**ADDENDUM #1**

INTERIOR ALTERATIONS – PHASE 3  
FOR THE  
EASTERN CENTER FOR ARTS AND TECHNOLOGY

February 17, 2022

This Addendum #1 dated February 17, 2022 shall be made a part of the Construction Documents dated February 1, 2022 for the proposed Interior Alterations – Phase 3 for the Eastern Center for Arts and Technology, Willow Grove, Montgomery County, Pennsylvania.

A002

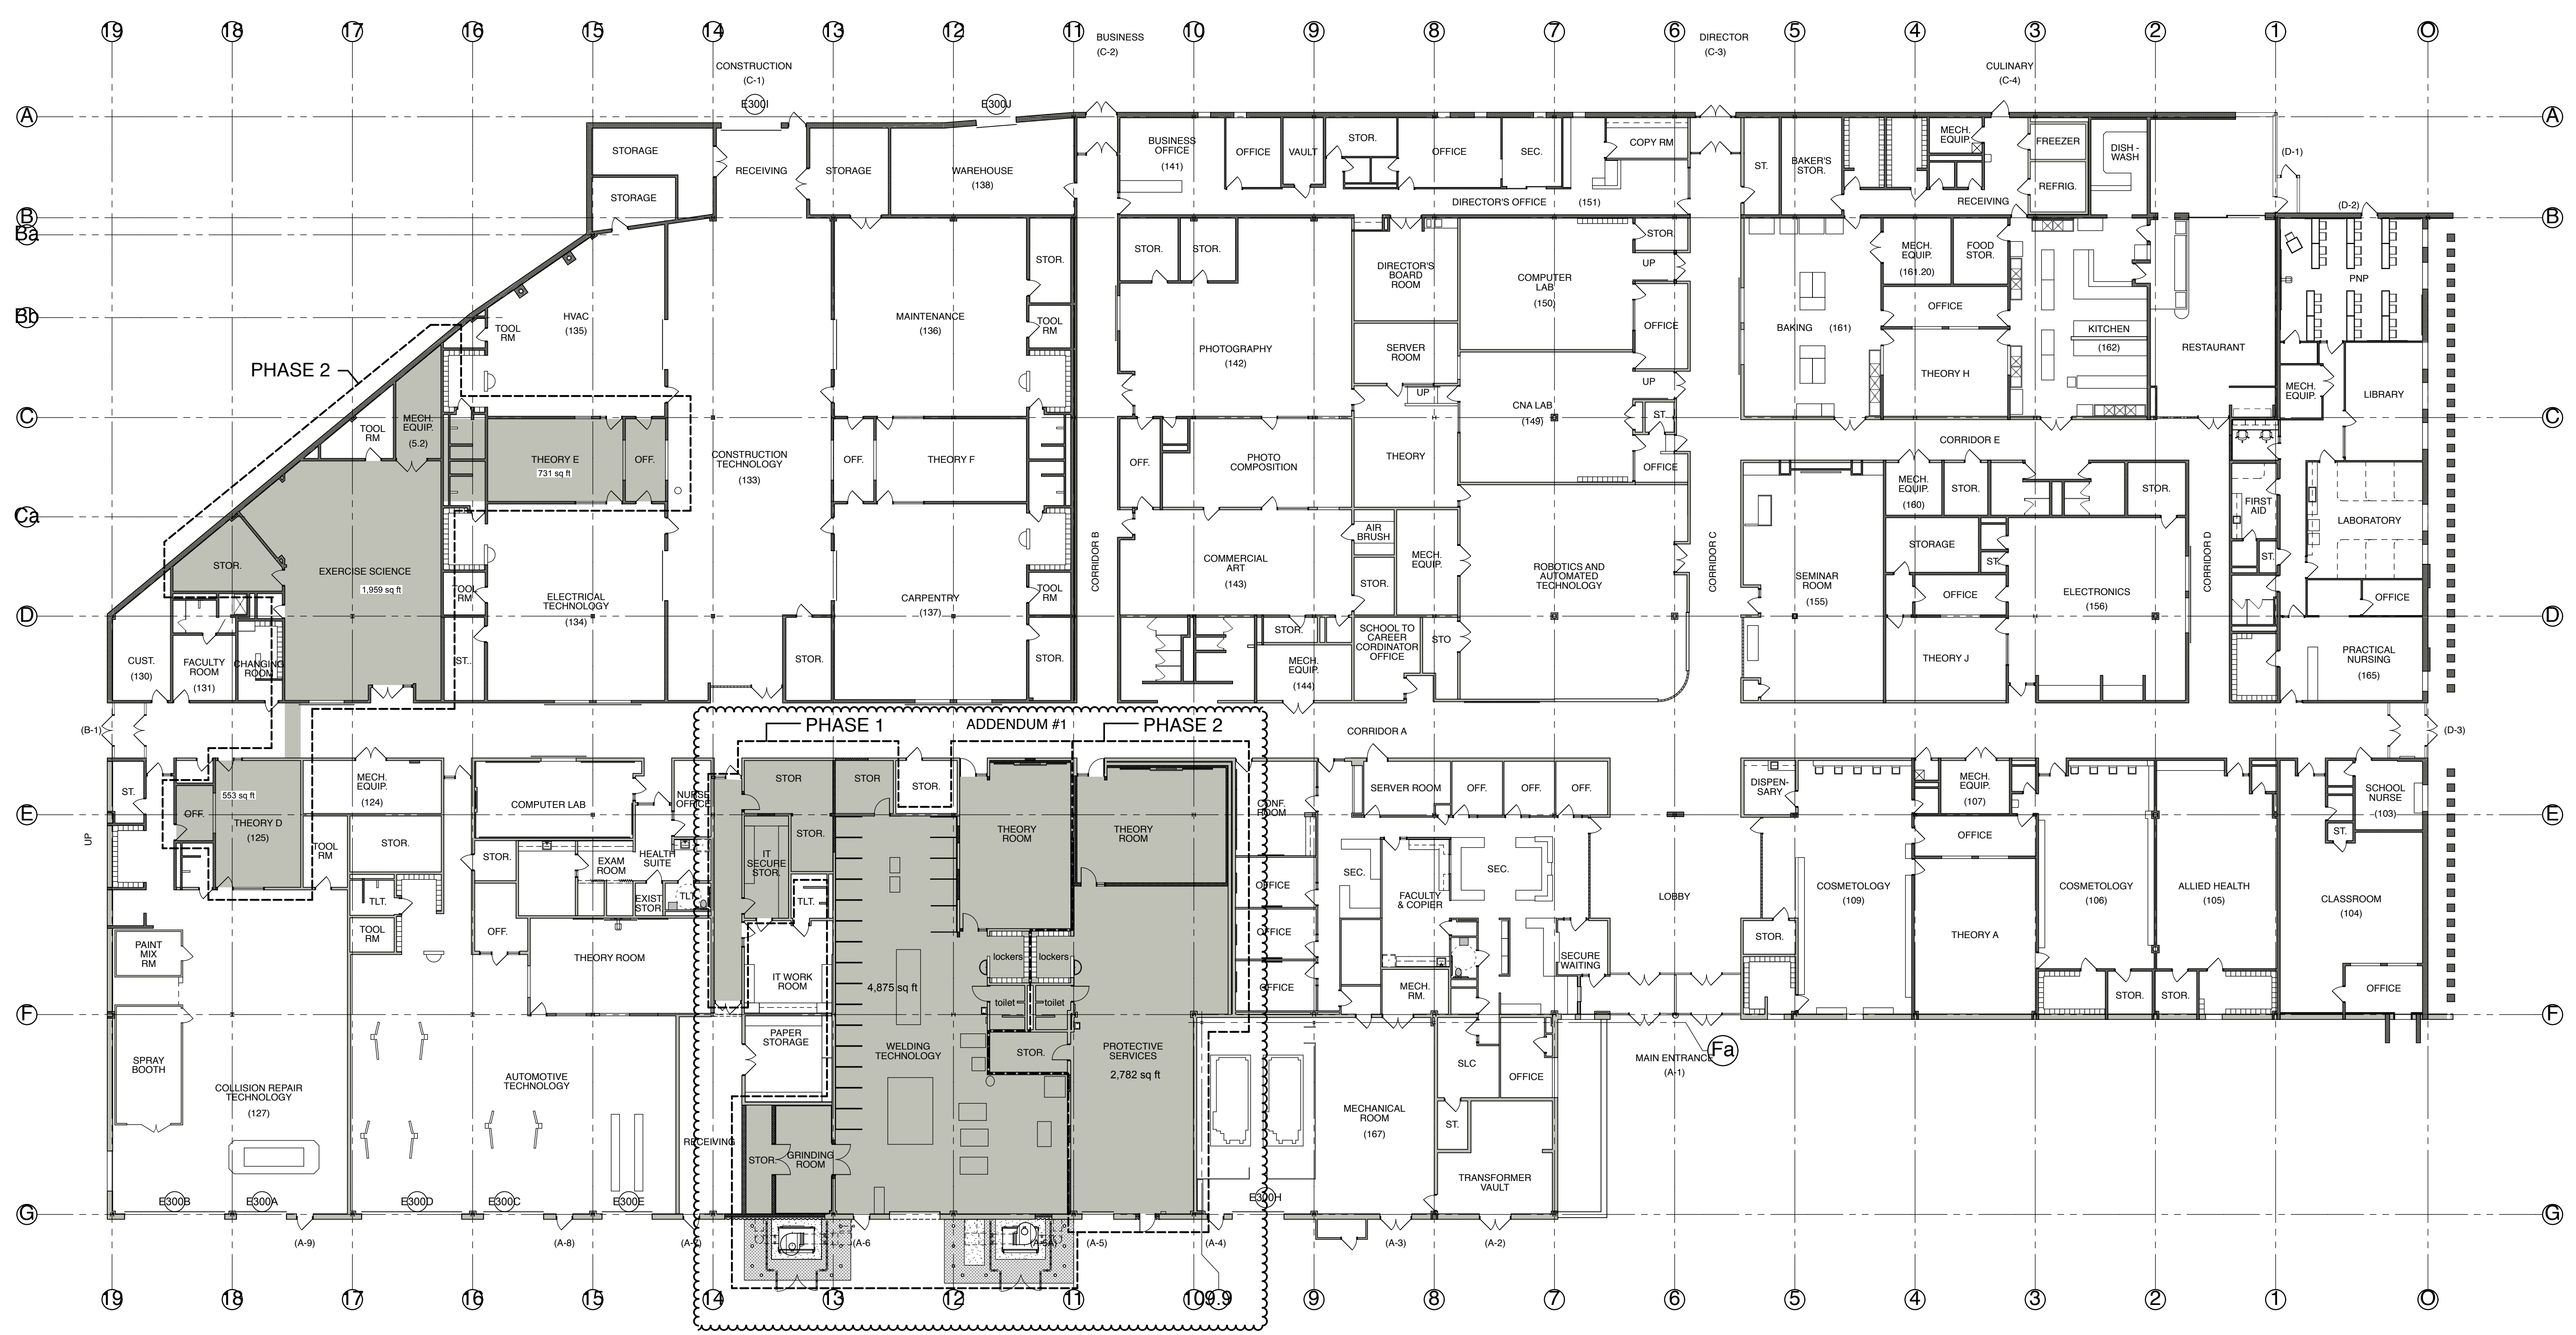
**DRAWING A002 – COMPOSITE FLOOR PLAN NEW CODE**

General Notes – Revise Paragraph 8 to read:

General Notes – Add paragraph:

“The General Contractor is responsible for providing all structural steel, miscellaneous steel, and loose lintels that are necessary to support all masonry openings, passages, windows, duct penetrations, etc., and to frame all wall, floor and roof openings. The General Contractor is responsible for reviewing all drawings of all contracts to determine the quantity, size, and locations of all masonry wall openings, and roof openings.”

“The Mechanical Contractor will provide all roof curbs for all rooftop mounted equipment. The General Contractor shall cut all roof openings, and install all new roof curbs. The General Contractor shall patch and flash the roof into the new roof curbs as required to maintain existing roof warranties.”
